**RE: Parcel 2770601540 50'x120' proposed subdivision; Application Numbers: 3020730;  
Response to Applicant's Motion to Dismiss the Appeal to Master Use Permit MUP-16-016  
(W), dated 19 August 2016.**

Appellant's Response to  
Applicant's 19 August 2016  
Motion to Dismiss the Appeal to  
the  
Master Use Permit  
MUP-16-016 (W)

Figure 2- Red lines showing necessary corrections to ECA Slide Review responses.

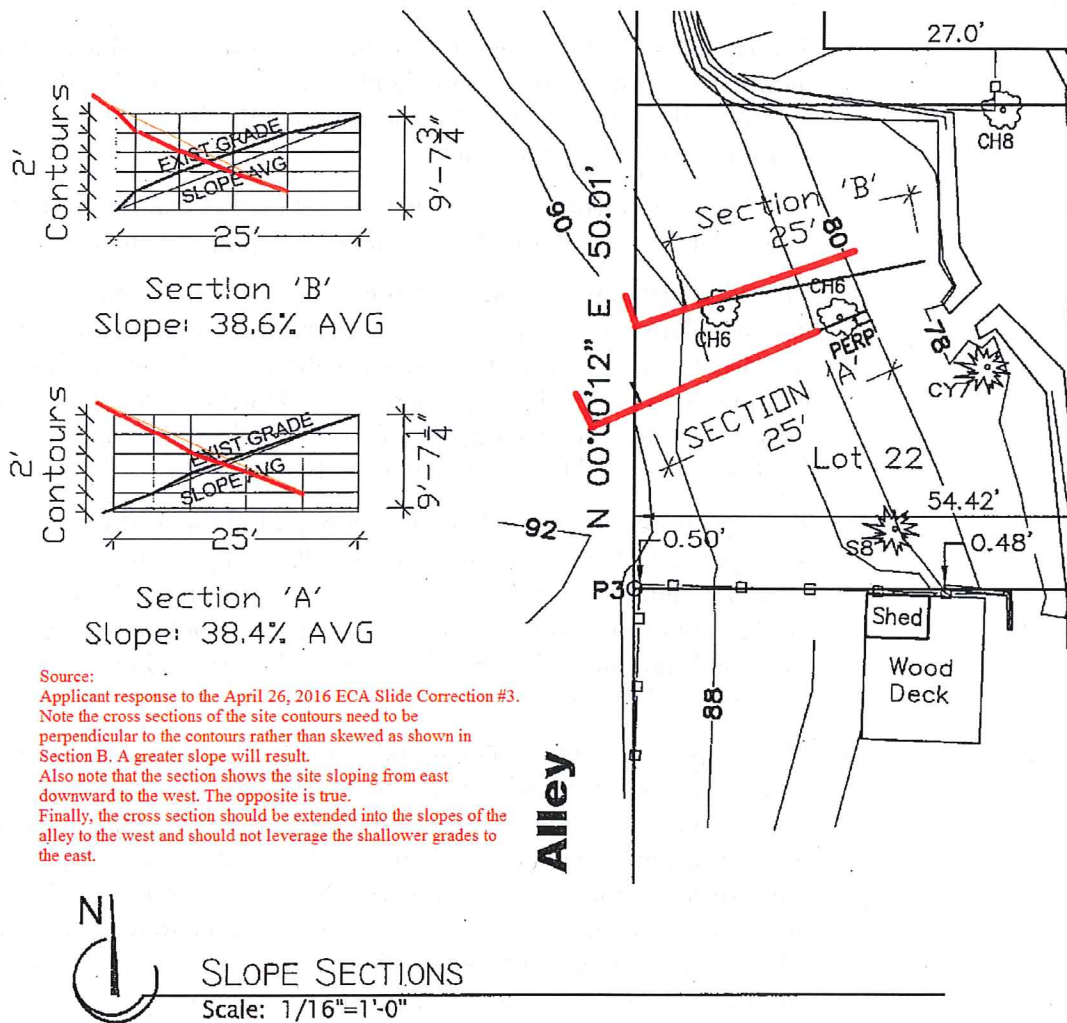
Item 'B2': Incorrect representation of the grades at the ECA:

In response to the April 26, 2016 ECA Slide Correction #3, the Applicants' professionals misrepresented the site slope properties, showing the grade pitching down to alley rather than upward to the alley. Cross section 'B' location was skewed from being perpendicular to the contours, thereby calculating to a slope less than the threshold of 40%. (see Figure 2 below as annotated by the Appellant from EXHIBIT 'AB', pages 4 and 5).

This error suggests the professional who responded to the city may not have been familiar with the site; and did not provide the City with accurate information to complete their risk assessment.

Figure 4A (above) and 4B (below) - Proposed site plan with permeable surfaces to four inaccessible parking garages.

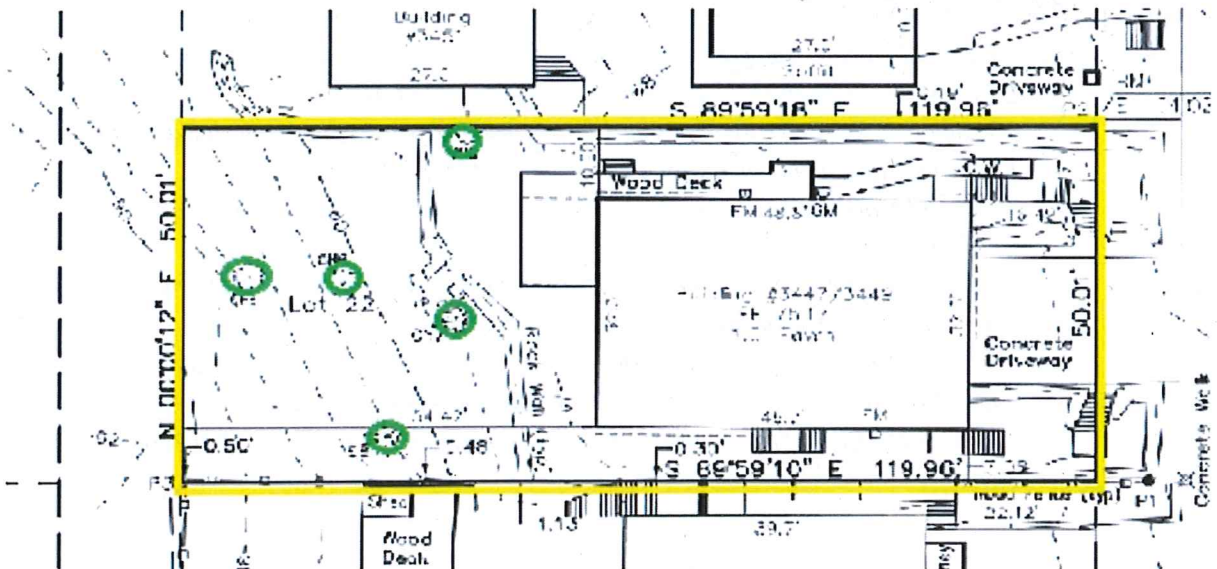
1           Whereas Line B. 11 a. and d, Light and Glare considers relative vehicle headlights  
2           that will impose into neighboring property living space windows as a result of a  
3           proposed driveway and four parking garages (Figure 4B). SMC requires screening  
4           from this type of light source, which has not been identified on drawings, even  
5           though the response suggests a fence will be provided.  
6

5           (a)     Appellant requests that the Applicant's consultants demonstrate with an  
6           engineered drawing vehicle maneuvers arriving and departing from the garages to assure  
7           4-cars will park within the garages on the site. (Reference Figure 4A on page that  
8           follows.)

SLOPE SECTIONS  
Scale: 1/16" = 1'-0"

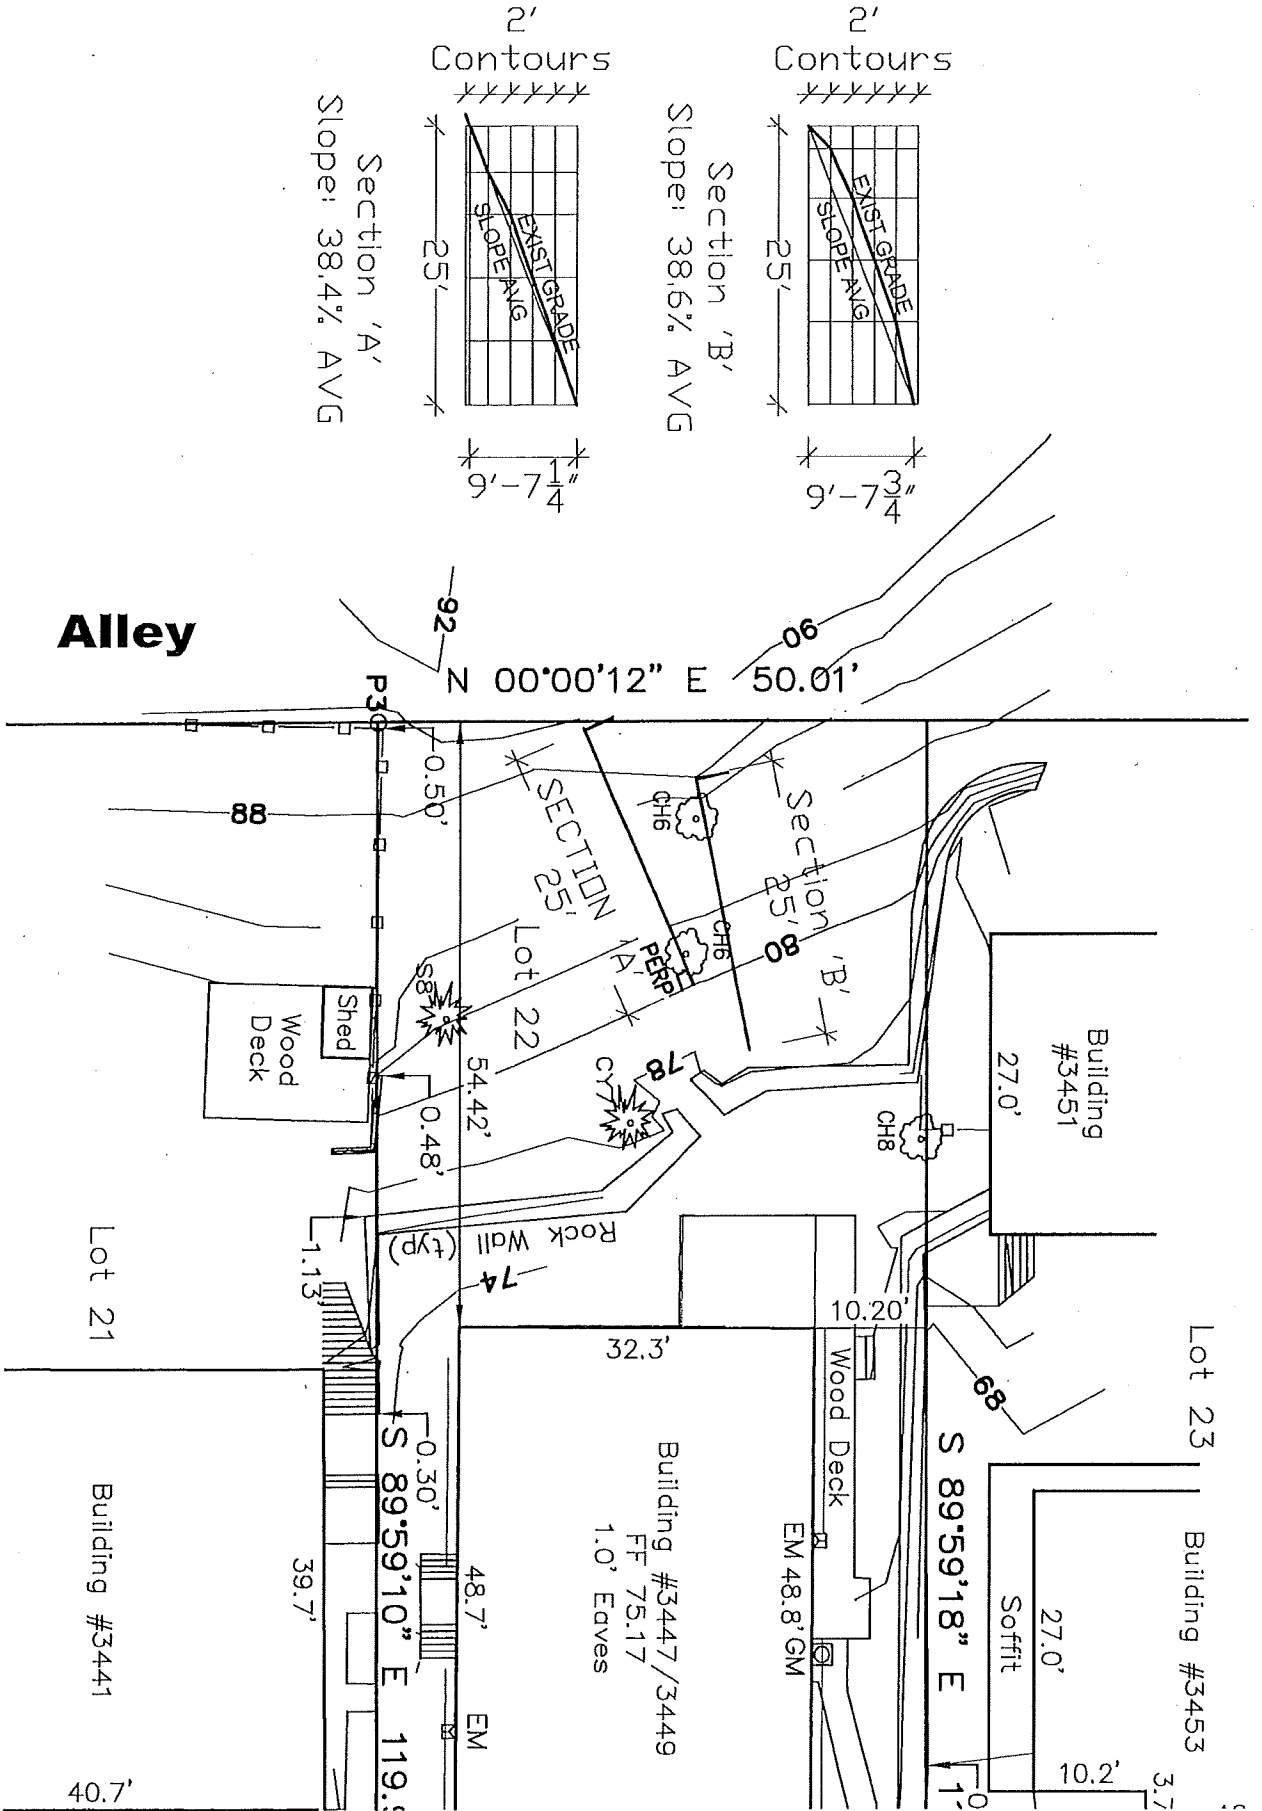
Sheet A1.0. Please adjust the Steep Slope Critical Area to be consistent with that shown on the attached site plan. Label this area as "Steep Slope Critical Area."
- 2 SMC 25.09.330 B.6. and SMC 22.170.070 B.2.c. Site Grading

Provide a temporary excavation plan demonstrating that adjacent properties will be protected during construction activities. The excavation plan does not need to be at final design level for this phase of permitting.

Show on the plans the permanent proposed grade contours. The final grade contours need to match the existing grade contours, as shown on the topographic survey, at the property lines.

1. REVISED TO SHOW REVIEWER DELINEATION. ALSO ATTACHED ARE GEOTECH ASSESSMENT, WHICH SHOWS THAT THE GENERAL SLOPE ON THE LOT IS NOT 40% (SEE ATTACHED BELOW). IT WOULD APPEAR THAT THE NEIGHBOR'S WALL TO THE NORTH HAS CREATED THE STEEP SLOPE SITUATION...WE REQUEST A STEEP SLOPES EXEMPTION TO TO THAT MAN MADE CONDITION.
2. A1.2 revised with a finished grade plan, showing every 2' contours connection with it's respective grades at property line.
